## ALERT SERVICE BULLETIN

**206-16-134**

**SUBJECT:** AIR CONDITIONER BLOWER MOTOR  
CONNECTOR, INSPECTION OF

**Title:** SB 206-110414; Bell 206 Air Conditioner Blower Motor Connector

**Contact Insertion System (DTM/DT/DTP)**

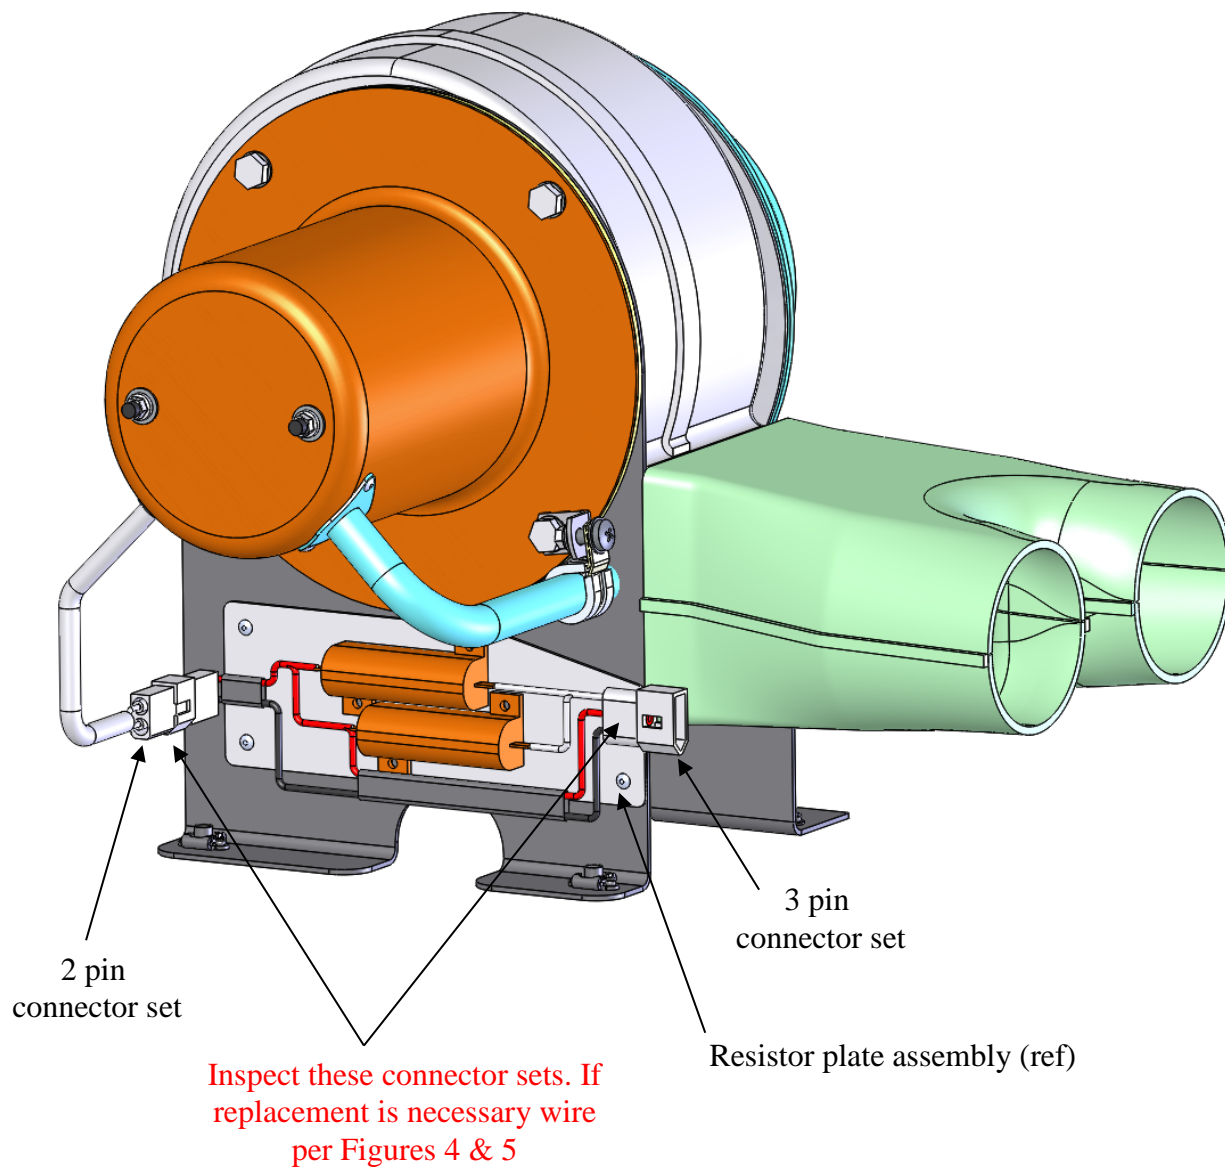
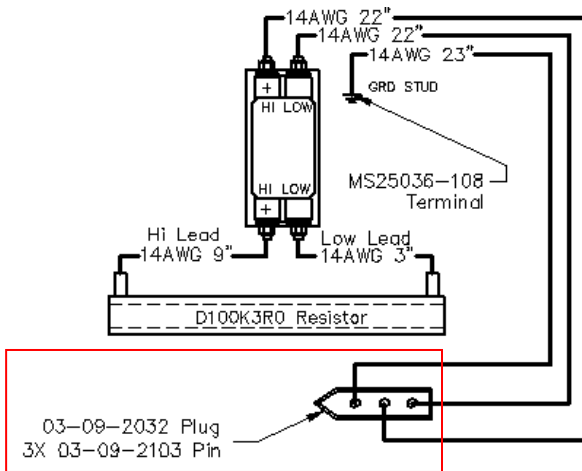
Installation instructions for new replacement connectors are per the view below and as shown on pages 6 and 7.

1. Grasp crimped contact approximately 1.0" (25.4mm) behind the contact barrel.

2. Hold connector with rear grommet facing you.

3. Push contact straight into connector grommet until a click is felt. A slight tug will confirm that it is properly locked in place.

4. Once all contacts are in place, insert orange wedge: receptacles - with half holes aligning with contacts. Plugs - with contacts aligning behind full holes. The orange wedge will snap into place.

1. Remove orange wedge using needle-nose pliers to pull wedge straight out.

2. To remove the contacts, gently pull wire backwards, while at the same time releasing the locking finger by moving it away from the contact with a screwdriver.

3. Hold the rear seal in place, as removing the contact will displace the seal.

**Figure 1** Aft Evaporator Blower Assembly S-6102EC-3 used in 206EC-200-9,-10,-11 AC kits

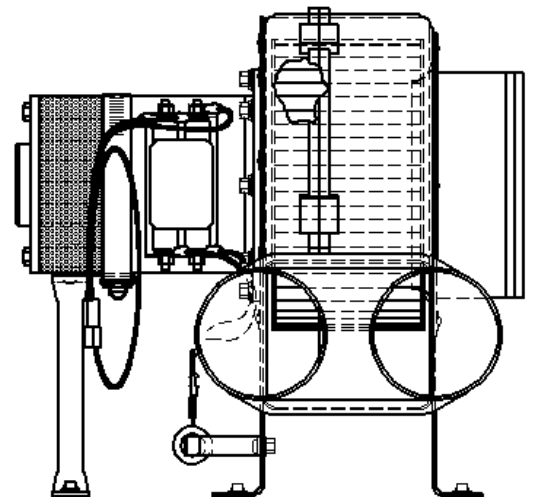
Locate each connector shown in Figures 1, 2, and 3. De-mate each connector and inspect both mates for signs of overheating, discoloration or plastic deformation. Gently pull (estimated 5-7 lb force) on each wire to verify the integrity of the contact's crimp. The contacts should be fully seated and locked in the housing so pulling gently on the wires will not dislodge the contacts from the housings.

If any signs of overheating of the housing are present or if the pull test fails, the system must be rendered inoperative and the connector housings and contacts replaced with new replacement connectors using Deutsch HDT-48-00 Crimping tool or equivalent MIL-DTL22520 Type 1 crimping tool before further operation. See Section B for information on how to contact Air Comm Corporation.

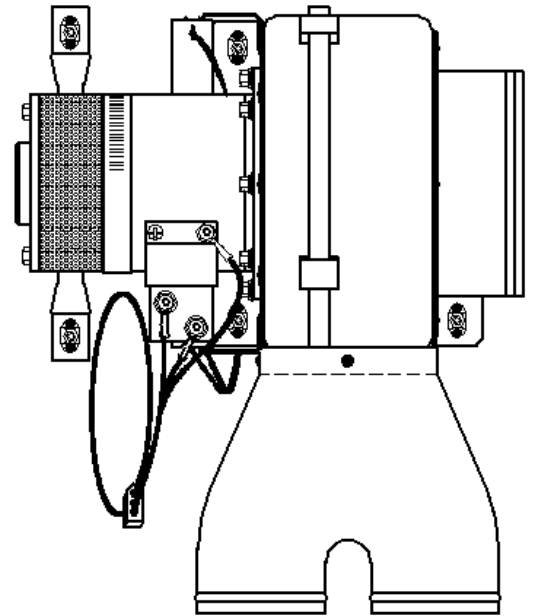
Inspect this connector.  
If replacement is necessary  
wire per Figure 6

Figure 3. Condenser Blower S-7060EC -1, -2 used on 206EC-200-212 Systems

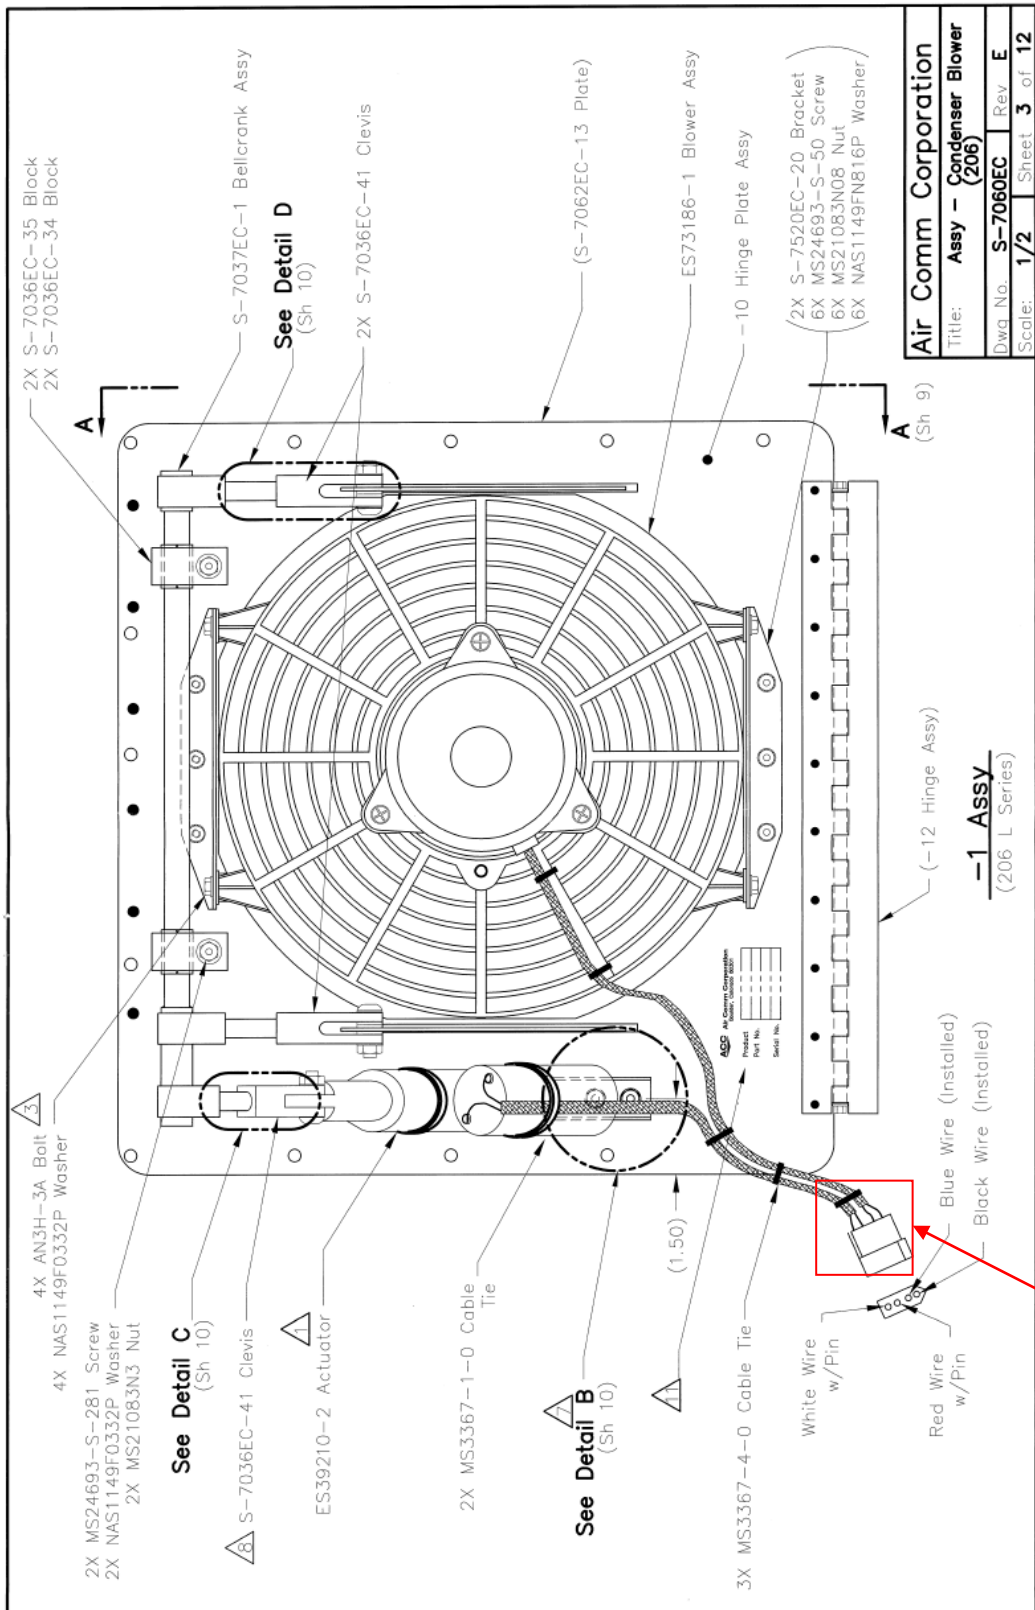
Inspect this connector

Note that the pinout of the replacement connector set is defined by the installer, however the wire alignment across the connector set must remain unchanged.
